RESPONSE TO COMMENTS
BHP Billiton Navajo Coal Company - Navajo Mine
NPDES Permit No. NN0028193

EPA received one set of comments from the San Juan Citizens Alliance, Diné Citizens Against Ruining our Environment (Diné Care) and the Clean Air Task Force. Incorporated by reference was the report titled: *A Preliminary Evaluation of the Potential for Surface Water Quality Impacts From Fly Ash Disposal at the Navajo Mine, New Mexico* D. A. Zimmerman, P.E., SETA, May 20, 2005. EPA has summarized and responded to significant comment below.

Figure 11. Topographic map showing zone representing "downstream of the mine."

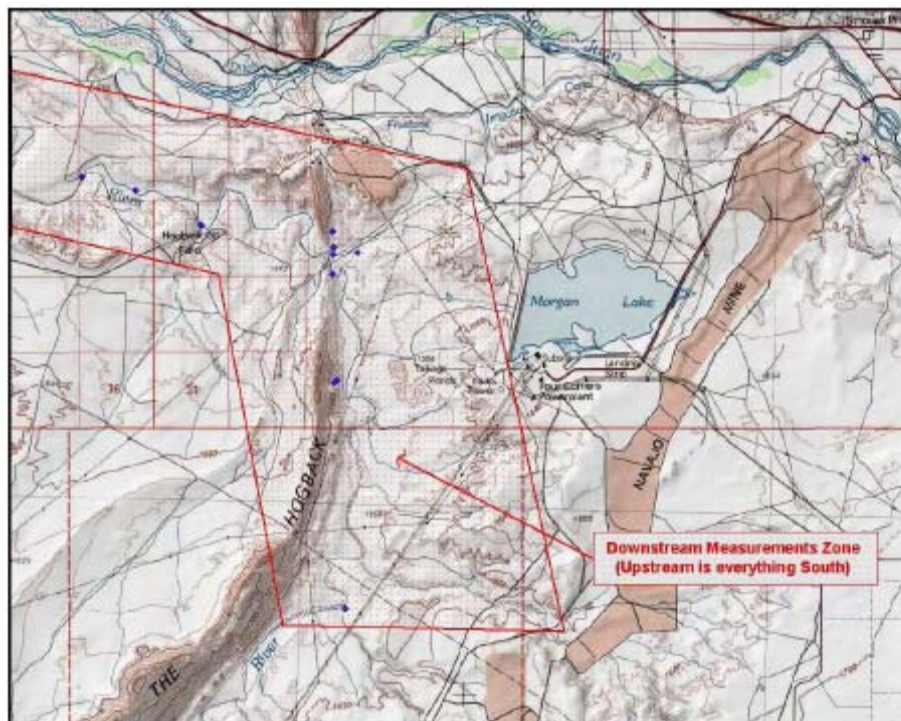
EPA generally agrees that comparing downstream and upstream boundaries to assess water quality is a viable approach. Collected data at designated boundaries was visually illustrated on Figure 11 and 12. However, two issues resonate from the report's assessment of spatial monitoring data; the lack of a clear border between upstream and downstream clusters and its rationale, and the disparity of sample sizes between upstream and downstream data sets per analyte. As mentioned previously, there were no clear justifications behind the separation of the two monitoring regimes. Based on Figure 12, there is an obvious disparity between utilized upstream and upstream monitoring points. The upstream regime for TDS data depicted in Figure 12 illustrates an overwhelmingly large area and pool of monitoring points in respect to downstream regime. The disparity can affect the results of the t-test since the two groups are not approximately balanced.

Third, EPA evaluated the physical locations of the upstream and downstream data and potential sources of impacts to the watershed. As noted above, the report defines “upstream” and “downstream” measurement zones as presented in two topographic maps, Figures 11 and 12 (pages 24, 26 respectively). Neither of these maps gives explicit geographical coordinates for the selected sites nor provides scales to assess distances and positions. Unlike Figure 11, Figure 12 does not provide a landmark point of references, i.e. geological formations (Hogback), waterways (San Juan River, Chaco River, and Morgan Lake), industrial operations (Navajo Mines, Four Corners Power Plant, and agricultural project sites), etc. Therefore, EPA has been able to reconstruct only a general description of the report’s presentation of upstream and downstream data.

As indicated, Figures 11&12 are diagrams of the Chaco Basin that have pooled downstream monitoring points. The downstream monitoring area covers roughly 44,000 acres (177 km²), and is located directly west of the mine site. Estimated area is based on Zimmerman’s aerial topographic map seen in Figure 11 and regenerated on Google Earth Pro (4.2.0205.5730) as seen in Figure A. A toolkit from the program positioned relevant landmarks (i.e. permitted outfalls) to their geographical coordinates and determined approximate distances among interested landmarks, i.e. outfalls, hydrologic features, monitoring stations, industrial operations, etc.

Figure 12. Map of water quality monitoring stations with TDS values plotted. Note that use of average values for USGS station 09367950 biases to the low side, the overall downstream average (see red line and plotted points in Figure 10).

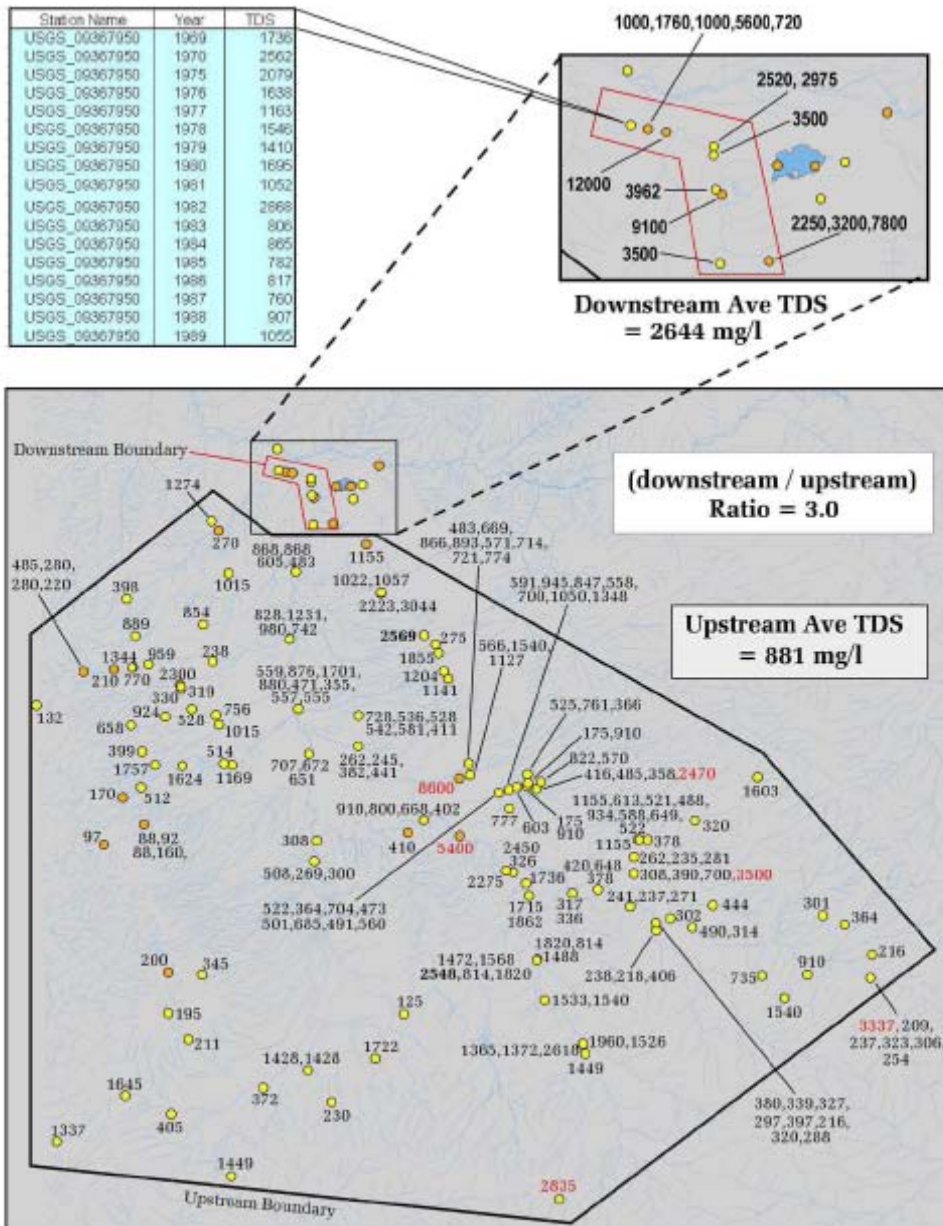
As seen in Table A, upstream data points predominated data collected downstream at varying ratios. This disparity is physically depicted in Figure 12 by its plotting of pooled upstream and downstream monitoring for TDS. Congruency for downstream and upstream stations layout of TDS to other listed analytes was not mentioned. It is also noted that the report did not specify if

In addition, based on Figure 12's TDS data, EPA noticed that the t-test was done incorrectly. The averages used in the statistical t-test should be discrete values. All 32 TDS results are not discrete because of the temporal correlation within each station with multiple results over time. The degrees of freedom in the test should be from $n=9$ downstream stations, not $n=32$ temporally correlated results.

As an example, Figure 12 presents a map of the downstream TDS concentrations. There are 9 separate sampling locations. Five of the sampling locations have only 1 sample for TDS, while one of the sample locations has 17 samples for TDS. One monitoring site in the downstream

area ranged from 720 to 5,600 mg/l of TDS over 5 samples, while the range for the entire data set was from 760 mg/l to 12,000 mg/l. The Zimmerman report summed the total of all data points and divided by the total number of samples, regardless of considerations such as sample location (e.g., middle of the river vs. shallow area prone to higher sediment concentrations) and time of sample (e.g., if the sample was taken during a low flow event when TSS is low or during a rain event when TSS would expected to be high). Given the extreme variability of results, ranging from 760 to 12,000, an average value as presented in the Zimmerman report is of limited utility to compare to another highly variable data set (e.g., the “upstream” data) and is highly dependent on the number of samples taken, the time of the sampling, and the location of the sampling stations.

Upstream measurement area is defined as “everything South”. Figure 12 portrays the upstream regime which is many times larger than the downstream area. EPA generated Figure C conveys “everything South”, however quantitative boundary assessments were difficult to reproduce. Based on Figures 11 and A, EPA hypothesizes land south of Outfall 010 acted as a demarcation point between downstream and upstream boundaries. EPA could not extract discernable landmarks or cartographic features from Figure 12 to estimate land area or perimeter approximations. However, we crudely estimated 3.17 million acres (12814.7 km²) and of over 80 miles (128.75 km) lengthwise and widthwise segments of the boundary for a general comparison. Figure D depicts sectioned upstream regime that includes landmark features such as remaining outfalls in Leasing Sites III and IV; Outfalls 013, 016, 017, and 018. No records of discharges from these outfalls exist.

Figure B-Approximated downstream boundary of BNCC based on Figure 12 of Zimmerman generated on Google Earth Pro.

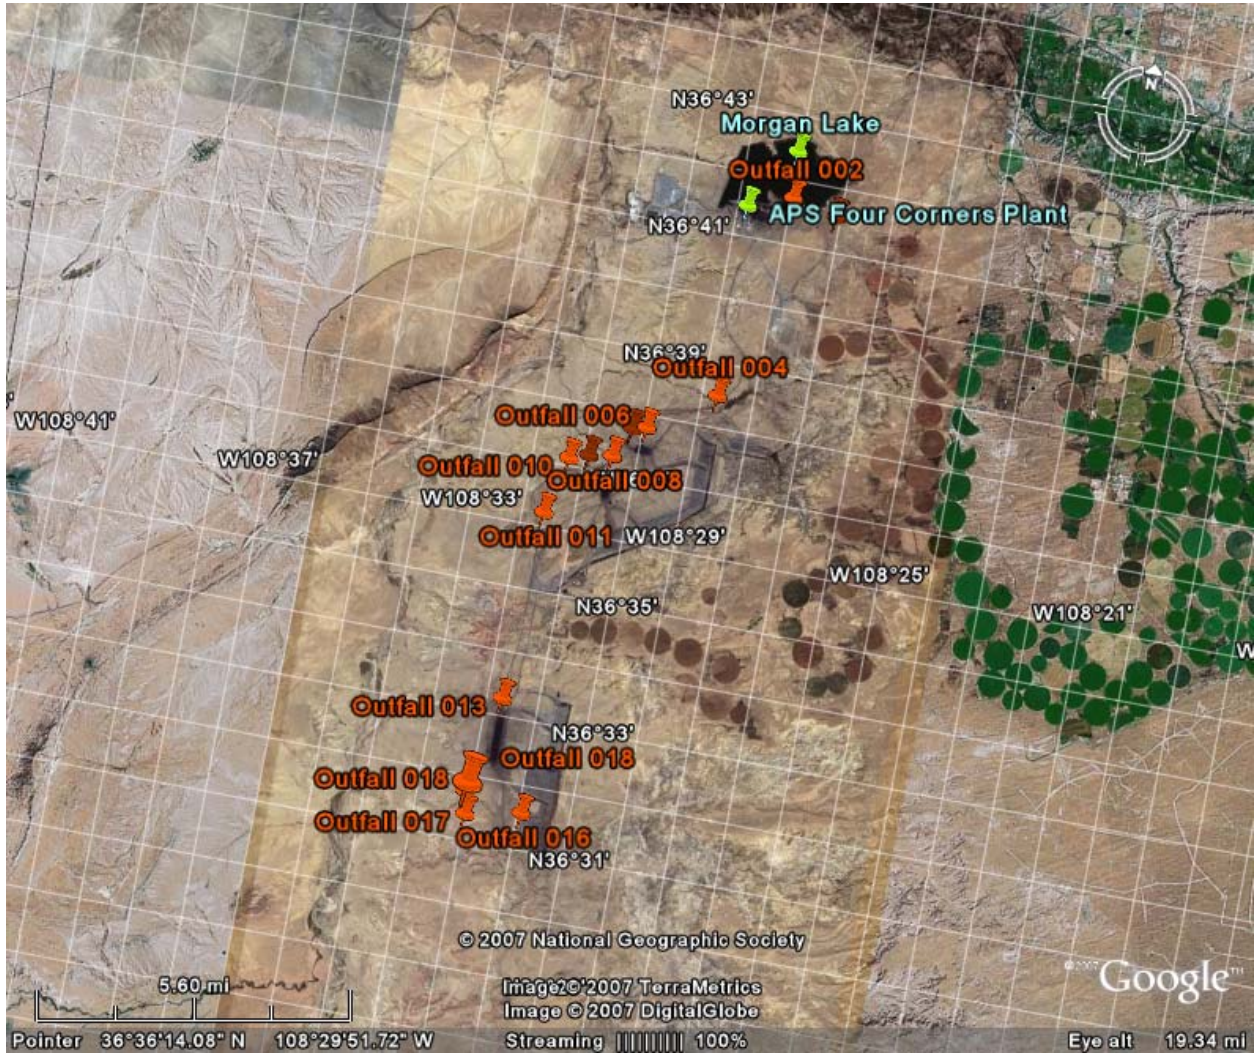
Zimmerman’s downstream boundary consists of Leasing Area I and II of BNCC which comprises Outfalls 001, 002, 004, 006-011 as seen in Figures A and B. Outfalls 006-011 neighbor ephemeral washes at close proximities of 60-760 feet (18-152 m). Services roads for haulage and fords transect and interrupt some washes that tributary to Chaco River.

Figure E. Estimated downstream and lower upstream boundaries with geographically positioned outfalls and NNEPA monitoring stations with most exceedances.

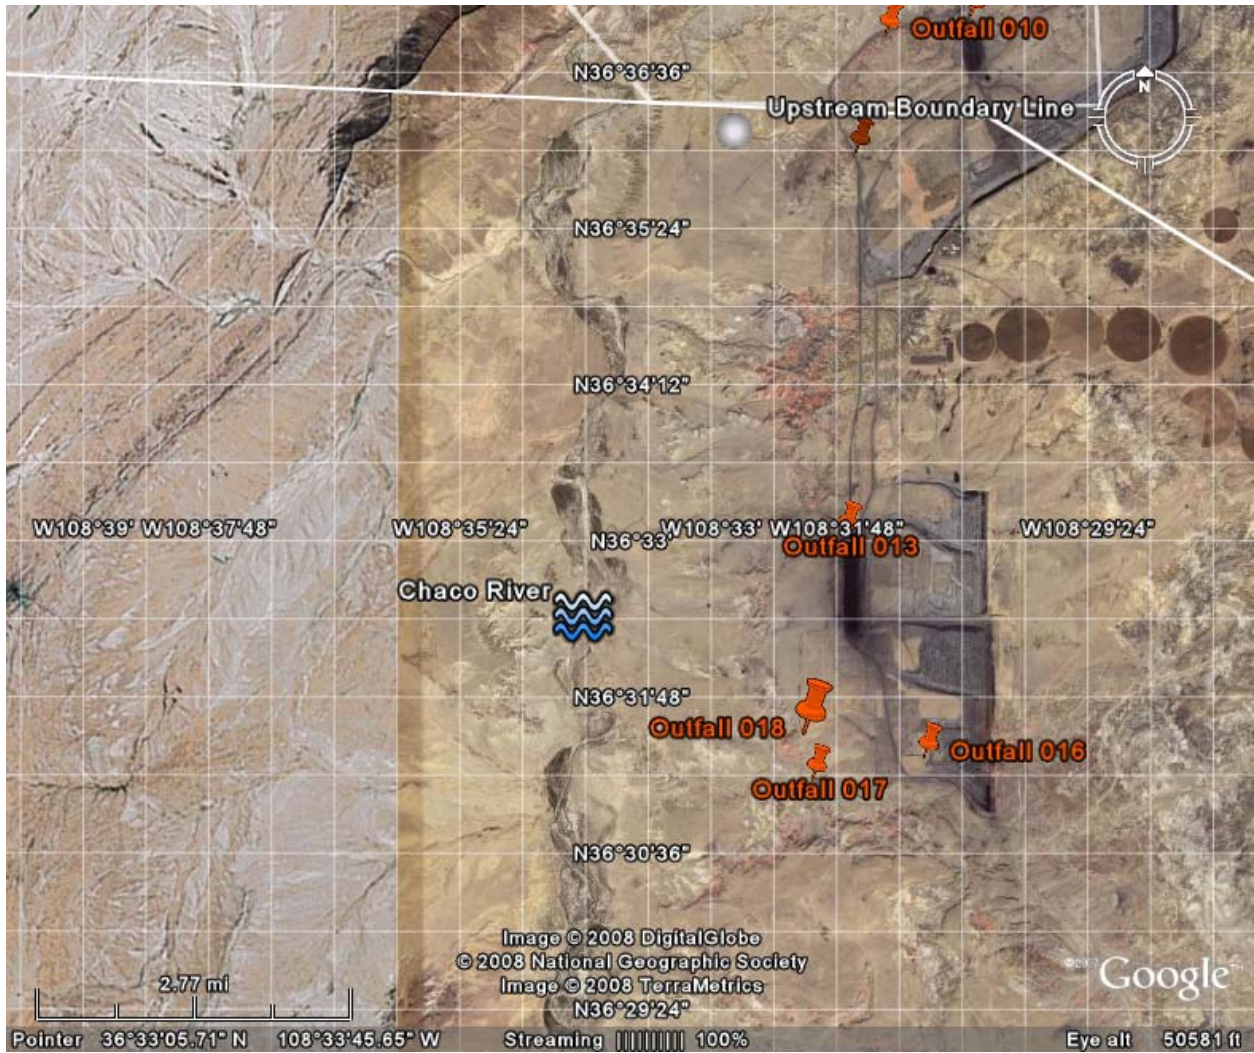
Navajo Nation Environmental Protection compiled data exceeding surface water quality constituents across 35 sites for over 8 years within San Juan Basin under agency sponsored monitoring programs. These sites included upper and middle San Juan River (i.e. Bitsui Wash, Ojo Amarillo Wash, Gallegos Wash, etc) and Chaco Wash (Chaco River, Chinde Wash, Sanostee Wash, etc). NNEPA tallied a total of 274 exceedances at Basin monitoring stations. The top three most frequented contaminants were total residue chlorine (TRC) ($n=42$), selenium ($n=29$), dissolved selenium ($n=28$) and the top three sites with most frequent exceedances were Ojo Amarillo Canyon ($n=64$), Gallegos Canyon ($n=55$), and North Chaco River ($n=53$). Ojo Amarillo and Gallegos stations are located approximately 6 and 18 miles east, respectively, of the mining site and are heavily influenced by NAPI activity and runoff. NNEPA Northern Chaco River monitoring station (06CHACORI01) neighbors Four Corners Power Plant and its mine tailings heap at approximately 6 miles (9.66 km) and 4.25 miles (6.84 km), respectively. The mine tailings heap neighbors Chaco River at approximately 1.0 miles (1.61 km). In addition, adequate baseline data is necessary to assess net impact from industrial activity to natural geological background. Images of mentioned outfall, NNEPA monitoring sites and their

comparative distances are provided in Figures E and F. EPA notes that Four Corners Power Plant resides within the downstream boundary and is in close proximity to Chaco River and a downstream NNEPA Chaco River monitoring station.
